Addendum: 7001 Dial Long Line Module and 7001A Network Terminating Dial Long Line Module (LSO*)

- 1.01 This addendum to practice section 837001, revision B (dated 2 December 1982), is issued to inform customers that short loop station-side applications may cause DLL station current to foldback to a low output current level (less than 100mA). Figure 5, in Section 2, is revised to reflect the effects of changes in ambient temperature on the performance of the foldback current level.
- 1.02 If this addendum section is revised, the reason for revision will be stated in this paragraph.

figure 5. Current-limiting curve

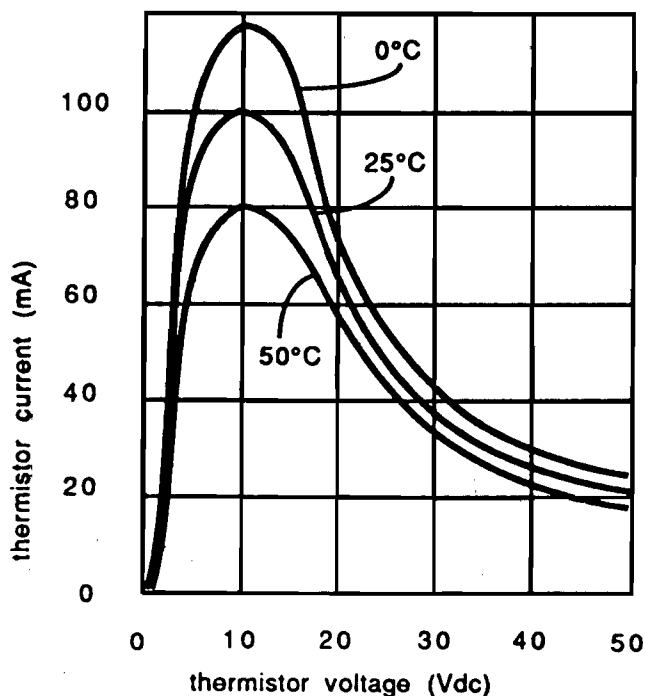
- 2.01 Typically, a battery voltage of -48Vdc requires a minimum external resistance of 200 ohms to prevent this foldback condition. For higher battery voltages, other minimum resistances are required. Contact Tellabs Customer Services Department for further information.
- 2.02 Replace the existing figure 5 with the following new figure 5.
